ORGANIZATION AND ADMINISTRATION

OA-1 *Correct the typo in the first sentence of LA Section 2.1.2. This sentence indicates that the IIFP management owns and operates the plant.*

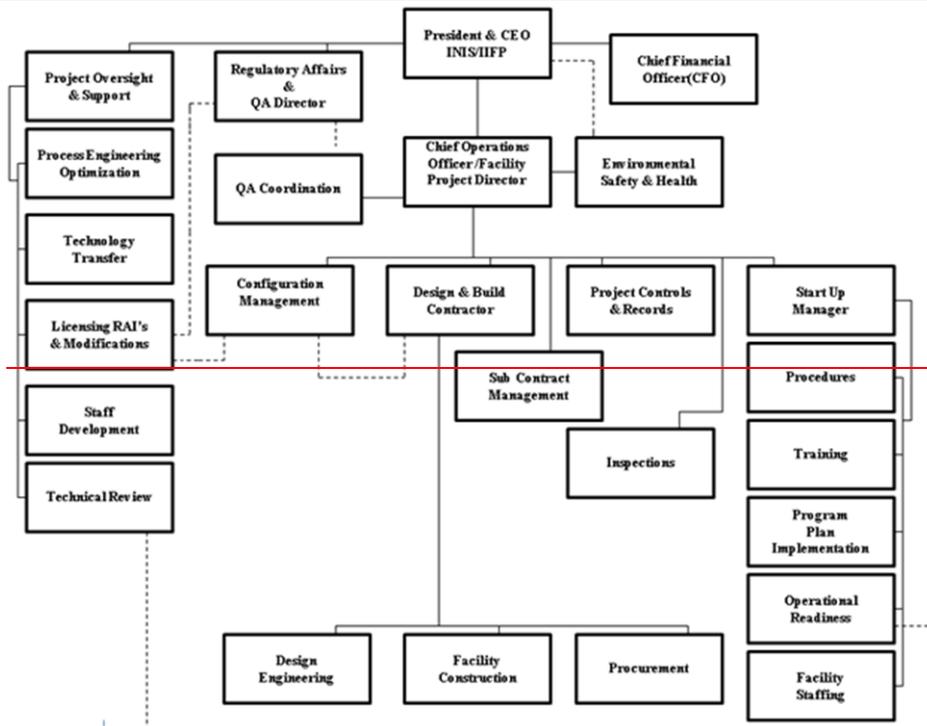
OA-7. *The organizational structures displayed in LA Figures 2-1 and 2-2 have a complex interconnectivity (“matrix structure”) which is not well defined in LA Sections 2.1.2 and 2.1.4. Consistent with NUREG-1520, Sections 2.4.3(1) and 2.4.3(2), provide the following information:*

Revision A figure below is deleted and replaced with Figure 2-1 on following page

Figure 2-1 IIFP Project Design and Construction Organization

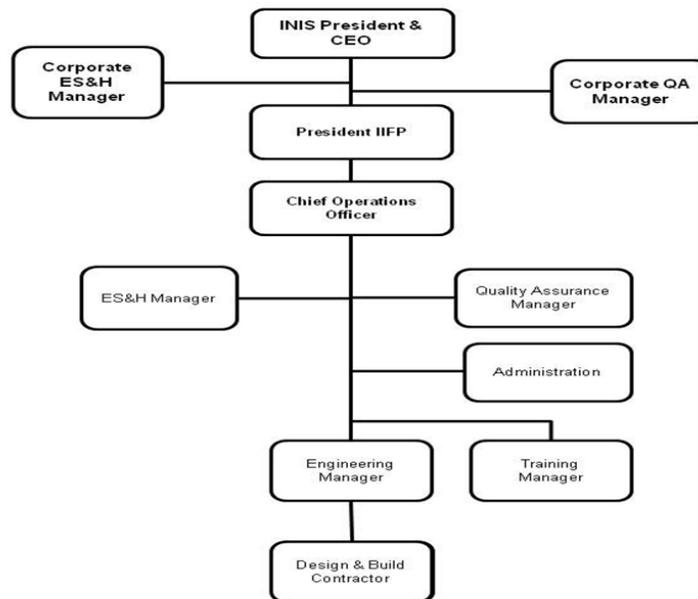
RESPONSE: Section 2.1.2 discusses the design and construction organization and Figure 2-1 shows the design and construction organizational structure for that organization. Figure 2-1 has been revised to eliminate the matrix organization, particularly for the QA and ESH functions, to show both a Corporate ESH Manager and a Corporate QA Manager in the INIS parent corporate organization and also an ESH Manager and a QA Manager (identified in Revision A of the LA as the QA Coordinator) for the IIFP Facility. Also see RAI OA-7A.

- A. *To demonstrate a clear, unambiguous set of management controls and communications among organizational units, reduce the complexity of LA Figures 2-1 and 2-2 or expand the explanations in 2.1.2 and 2.1.4, or both. This may involve reducing the level of detail in the figures, focusing the explanation in the text to explain the groups responsible for the “design, construction, and operation of the facility [NUREG-1520, 2.4.3(1)],” removing or explaining dual reporting relationships, making the Figures layouts easier to read, etc. Any dual reporting listed in the Figures should be explained in the text.*

- C. *The application indicates that the COO has responsibility for the design, engineering, construction, startup, operation, maintenance, etc. However, the COO/Commercial Facility Project Director (CFPD) (Design/Build (DB) phase) is not at the top of the Figure 2-1; nor is the COO/Plant Manager (operations phase) at the top of Figure 2-2. In addition, several other groups are parallel or above the COO for both phases. Consistent with NUREG-1520 2.4.3(1), clearly indicate which individuals listed in LA Figures 2-1 and 2-2 are ultimately responsible for overseeing the design, construction and operation of the facility.*

RESPONSE: The matrix structure has been omitted from organizational charts (Figures 2-1 and 2-2) with the corresponding dual reporting text deleted in the LA Chapter 2 Revision B rewrite of Sections 2.1.2 and 2.1.4.

Figure 2-1 has been revised with the IIFP President at the top of the IIFP organization and the highest authority within IIFP. The IIFP President reports to the parent corporation INIS President/Chief Executive Officer. The other management individuals in the parent corporation that interrelate with the IIFP President are the Corporate ESH Manager and the Corporate QA Manager. These parent corporate staff managers interrelate with the IIFP President by assisting the IIFP COO and providing support to the IIFP ESH and QA management (See Section 2.2.2 of the IIFP LA Chapter 2 Revision B attached). The COO reports directly to the IIFP President and as such is delegated the line organization authority for the responsibility of managing the administration, ESH, QA, engineering, training and supporting contractor functions during the licensing, design and construction of the IIFP Facility. Once the IIFP Engineering Manager is hired the COO will assign responsibilities and delegate authority to the Engineering Manager, who reports to the COO, for providing design authority and direct oversight of the Design and Build Contractor and for ensuring professional and contractor support is in place to perform any required Integrated Safety Analysis and licensing documentation.

Section 2.1.2 of the IIFP LA Chapter 2, "IIFP Design and Construction Organization Structure" addresses the organization structure during the DB phase of the IIFP Project. Figure 2-1 addresses that organizational structure. The roles and responsibilities of individual positions in managing the design, construction and operation of the facility are discussed in response to RAI OA-7A above.

Figure 2-2 Plant Operation Organization

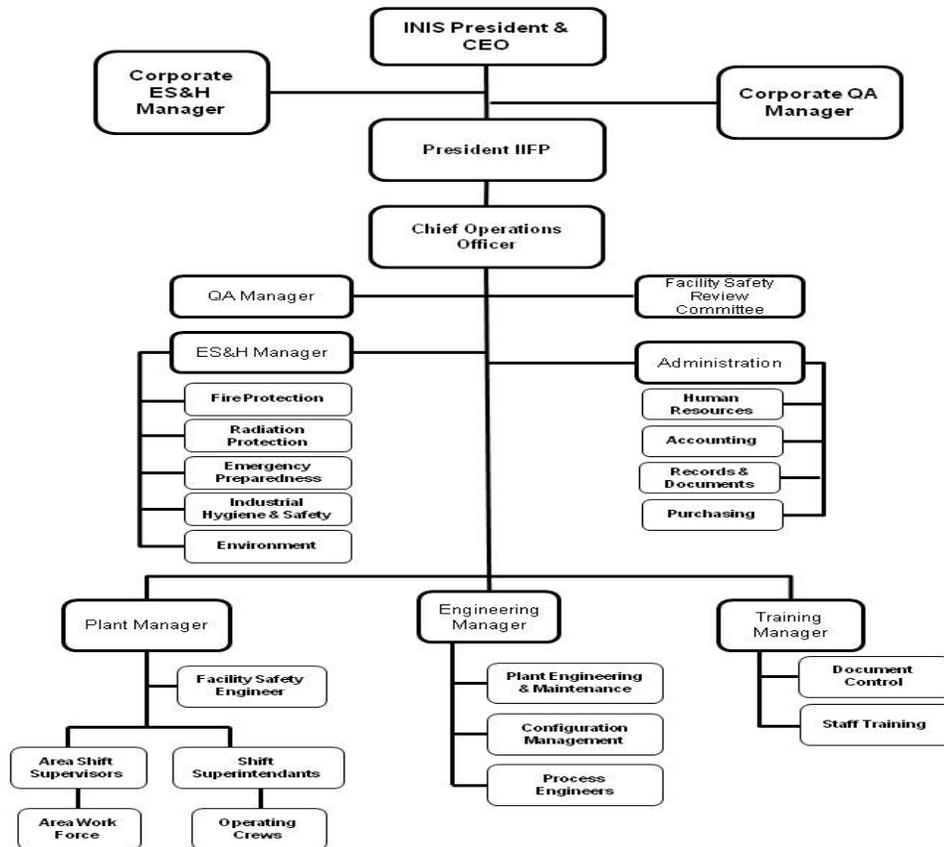
C. LA Section 2.2.3 states that the Regulatory Affairs and Quality Assurance Director (RAQD) is appointed by the INIS President/CEO. This appears to indicate that the RAQD is an INIS employee and not an IIFP employee. The section also states that the RAQD is responsible for the ESH and QA policies. Consistent with NUREG-1520, Section 2.4.3(3), state in the LA that the RAQD is an IIFP employee. Clarify the reporting relationship and management structure between RAQD, COO/Plant Manager, Quality Assurance Coordinator (QAC), and ESH.

- C. *The bulleted list in Section 2.1.4 on Pages 2-5 and 2-6 appears to match positions listed in LA Figure 2-2. Ensure that the management positions listed in Figure 2-2 match the positions contained in the bulleted list.*

LA Section 2.2.2 describes the Chief Financial Officer (CFO). This position does not appear in LA Figure 2-2. Consistent with NUREG-1520, Section 2.4.3 (2), clarify what happens to the CFO in the transition from DB to organization.

RESPONSE: The organizational chart for the Plant Operation Organization of the IIFP (Figure 2-2) has been revised to replace the position of the RAQD with both a Corporate QA Manager and a Corporate ESH Manager reporting to the INIS President and CEO. The responsibilities for these corporate positions are provided in Section 2.2.2.of the attached rewrite (Revision B) of the IIFP LA Chapter 2.

The revised Figure 2-2 shows the same organizational structure during the plant operations phase. A position of Plant Manager reporting to the COO was added to the Plant Operation Organization chart. The responsibilities for the Engineering Manager, the COO, the Plant Manager, and the IIFP President are delineated in Section 2.2, "Key Management Positions, Responsibilities, and Qualifications."

RESPONSE: The subject bulleted list does not include all the positions listed in Figure 2-2. It has been revised to include the IIFP Facility functions where the IIFP COO provides leadership and responsibility.
